ZONING AMENDMENT,

& SUBDIVISION STAFF REPORT Date: September 6, 2007

SUBDIVISION NAME Cody-Zeigler Commercial Subdivision

LOCATION 950 Cody Road North

SITE PLAN

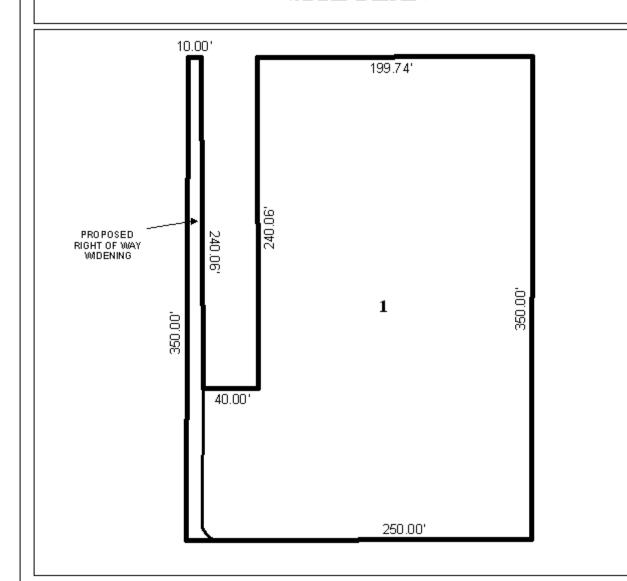
The site fronts onto Cody Road and Zeigler Boulevard, both proposed major streets. A note on the plat indicates that land has been dedicated for a service road along Cody Road, as required by the conditions associated with the rezoning of the site in 1978. The preliminary plat also depicts the 10-foot required dedication along Cody Road, per the most recent approval in February 2007.

The 25-foot minimum building setback line from all street frontages, required in Section V.D.9., is not shown on the plat, but would be required on the final plat, if approved.

Finally, applications for rezoning are required to include a site plan that depicts proposed development. No site plan depicting development was provided with this application.

- 1) dedication of 10 feet along Cody Road, as depicted on the preliminary plat;
- dedication of sufficient right-of-way at the intersection of Cody Road and Zeigler Boulevard for radius to be approved by Traffic Engineering, as depicted on the preliminary plat;

- 3) placement of a note on the final plat stating that the site is limited to one curb cut to Zeigler Boulevard and two curb cuts to Cody Road, with the size, location and design to be approved by Traffic Engineering;
- 4) provision of a buffer in compliance with Section V.A.7. of the Subdivision Regulations;
- 5) illustration of the required 25-foot minimum building setback line along both street frontages; and
- 6) labeling of the lot with its size in square feet.
